**Subject: Annual Inspection Report
North Pickens Airport (3M8)**

Annual Inspection Report

North Pickens Airport (3M8)
Reform, Alabama

North Pickens Airport
Reform, AL.
Obstruction Evaluation
4/15/2021

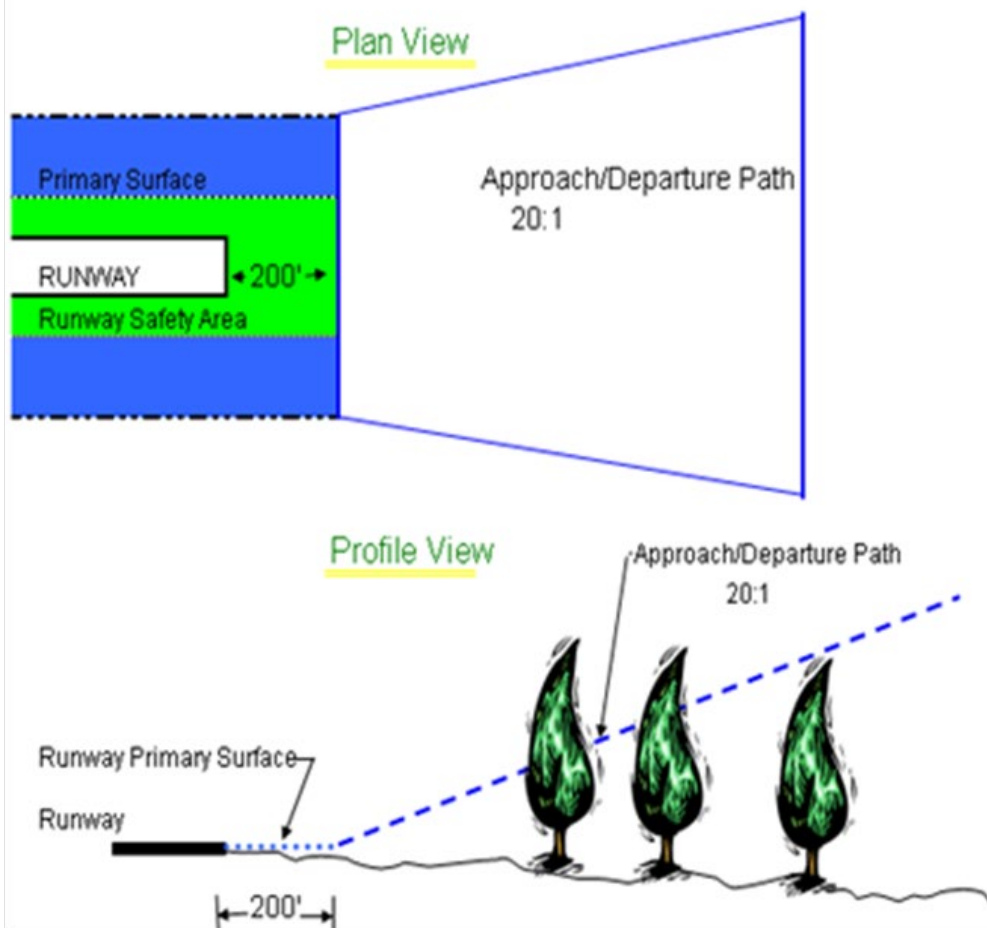
- Runway 01- No obstructions (See Photo #1).
- Runway 19- Tree identified as Tree #9 and surrounding foliage is a violation to the ALDOT 20:1 Approach/Departure Path (See Photo #2).

9. Trees 9' Abv. RWY
313' From RWY End
112' L of CL
12:1 Obst. Clnc

- Remove all obstructions within the Required 20:1 Approach/Departure Path.
- The obstructions detailed in this report are representative and may not include all obstructions in the Approach/Departure Path.
